Mask Set Errata for Mask 2L31R

This mask set errata applies to the mask 2L31R for these products:

- MC9S08GB60
- MC9S08GT60
- MC9S08GB32
- MC9S08GT32
- MC9S08GT16

Figure 1. HCS08 SIM Reset Lockup

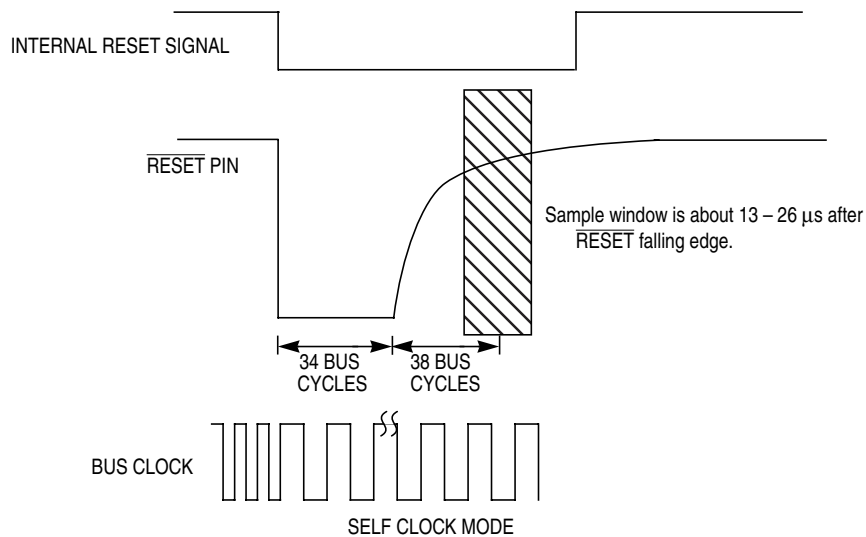
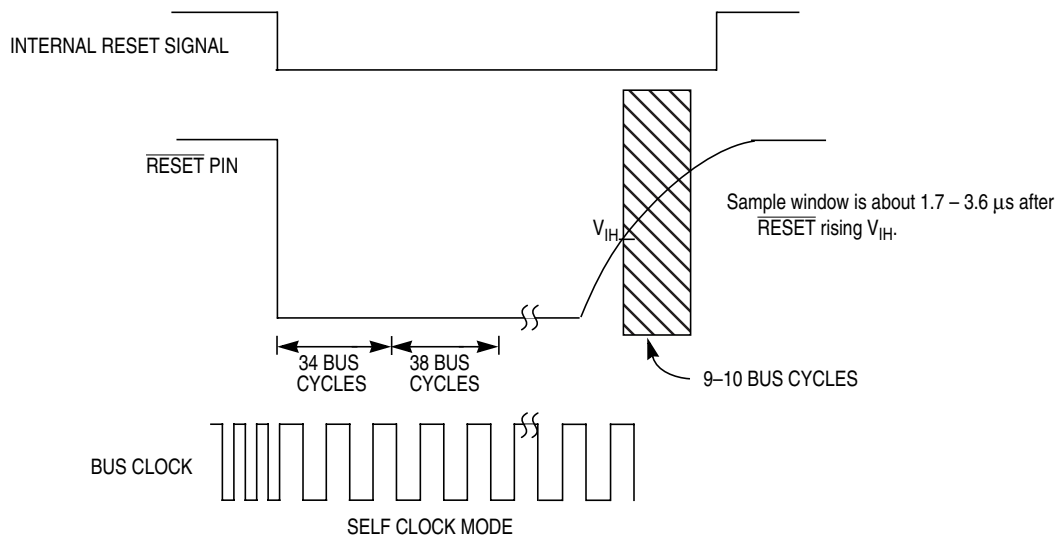
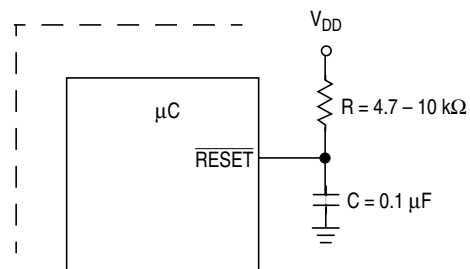
If a falling edge is detected on the external reset pin at either of two sample points, the MCU will cease operation and will recover only after a power-on reset.

Case 1 — After detecting a reset signal, either internal or external, the internal reset circuit latches the cause of the reset, forces a low level on the external $\overline{\text{RESET}}$ pin for about 34 bus cycles, releases the pin, and samples the pin level about 38 bus cycles later. The ICG will revert to self-clock mode (SCM) at the beginning of the reset cycle. Therefore, the first sample window is about 13 μs to 26 μs after the initial reset signal, due to the frequency range and characteristics of the internal oscillator.

Case 2 — After remaining in reset for an extended period of time due to an externally applied low level on $\overline{\text{RESET}}$, the internal reset circuit will sample the pin level about 9 to 10 bus cycles after the pin raises above its V_{IH} level. The ICG will revert to self-clock mode (SCM) during reset. Therefore, the second sample window is about 1.7 μs to 3.6 μs after the reset signal rises above V_{IH} , due to the frequency range and characteristics of the internal oscillator.

To avoid multiple edges on the $\overline{\text{RESET}}$ pin due to switch contact ringing or EMC noise, eliminate any voltage bounce through RC filtering. A 0.1 μF capacitor to ground and an external 4.7 k Ω to 10 k Ω resistor to V_{DD} works well to ensure noise suppression.

In addition to RC filtering, avoid spurious edges on the $\overline{\text{RESET}}$ pin caused by external active circuitry such as low voltage detectors and watchdog components. Do this by ensuring that external circuitry cannot drive $\overline{\text{RESET}}$ low within 10 bus cycles of the release of $\overline{\text{RESET}}$.
